Final
**Supplemental
Remedial Investigation Work Plan
for Area of Concern (AOC) E**

**The Former U.S. Naval Ammunition
Support Detachment (NASD)
Vieques Island, Puerto Rico**

Prepared for
**Department of the Navy
Atlantic Division
Naval Facilities Engineering Command**

November 2005

FIGURE 1
 Proposed New Sample Locations for AOC-E
 Former NASD, Vieques, Puerto Rico

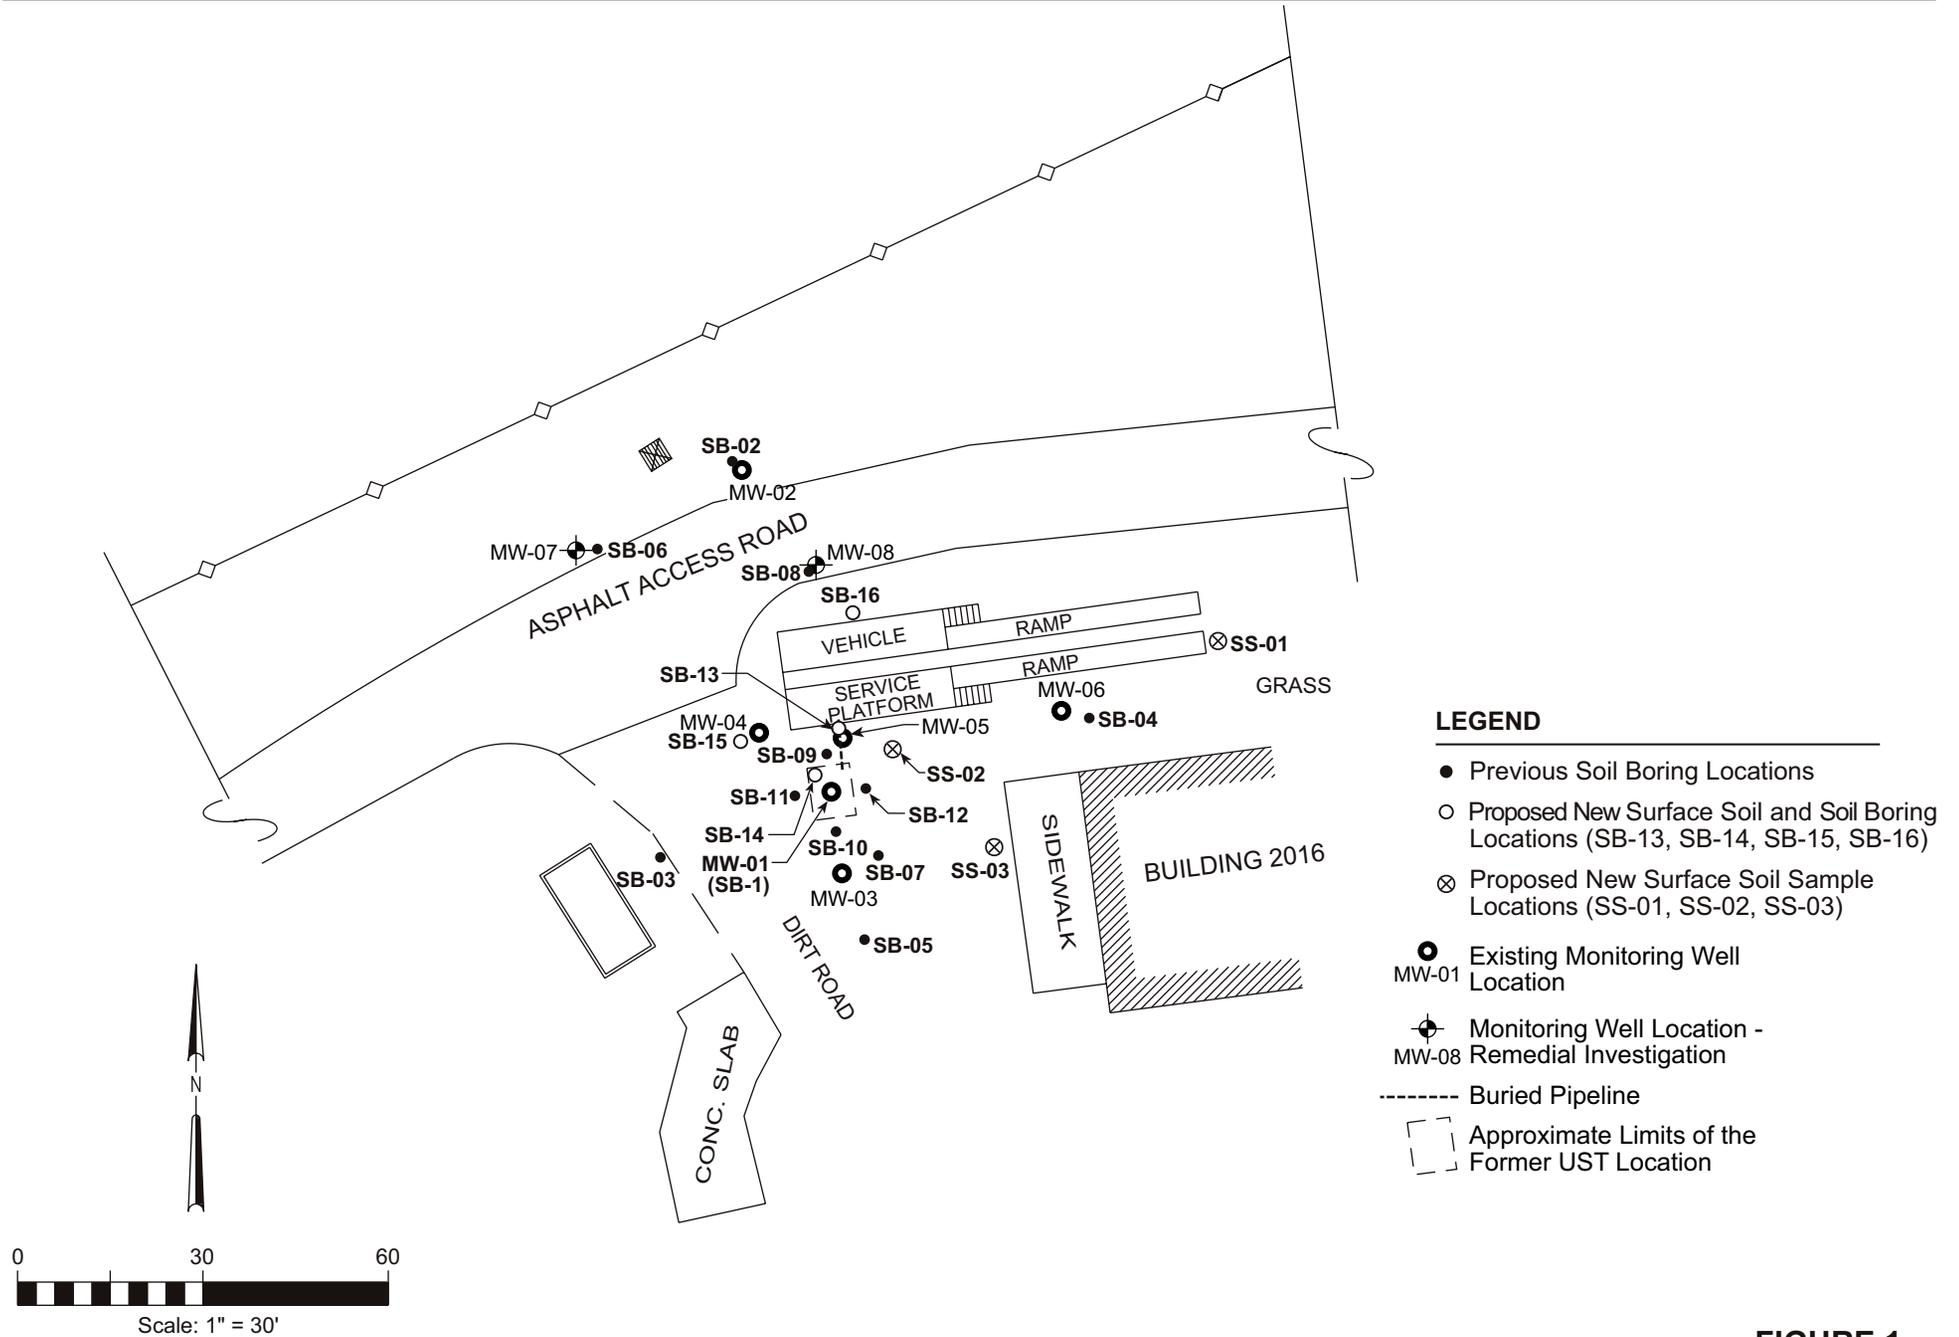
Figure 1, which shows the proposed sample locations, will be revised to include the existing monitoring wells.

Figure 2
 Conceptual Site Model for Human Health and Ecological Risk Assessment at AOC E
 Former NASD, Puerto Rico

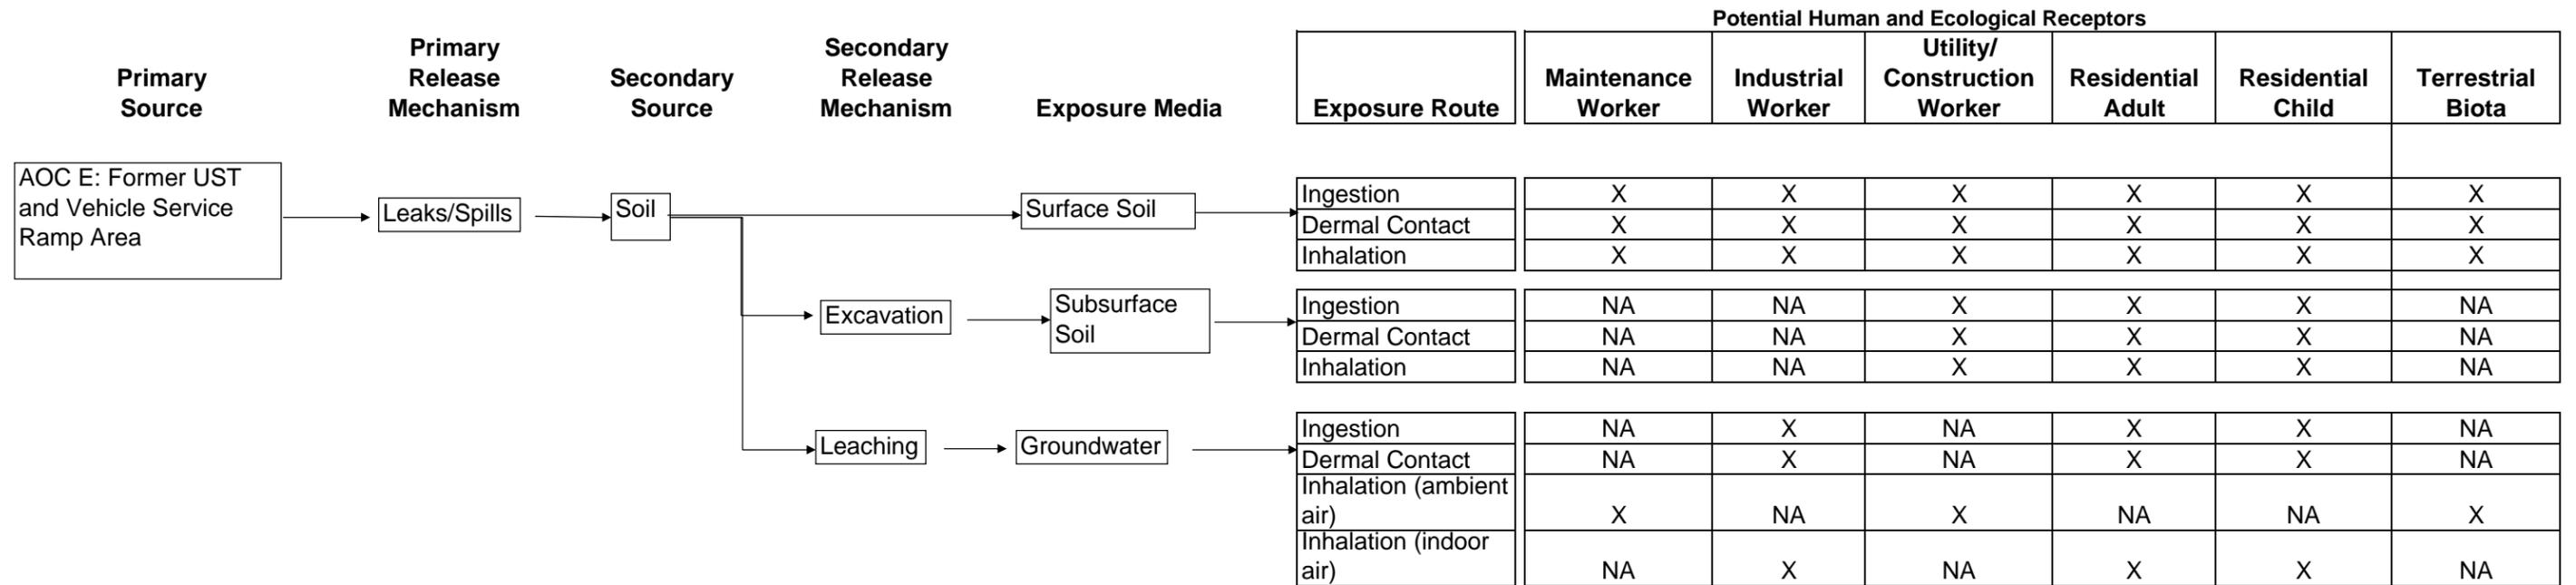
Figure 5-1, Conceptual Site Model for Human Health and Ecological Risk Assessment

- 2) **The conceptual site model (CSM) indicates that the indoor air pathway is a potentially complete exposure pathway. Please clarify how this exposure pathway will be evaluated and what type of data will be used to evaluate this pathway.**

The conceptual model will be revised as suggested.

Currently, there are no buildings within the contaminated area of AOC E, but the pathway has been considered complete for a potential future resident. The data will be evaluated for this pathway using EPA's November 2002 Draft Vapor Intrusion Guidance. This information will be added to the revised SAP.
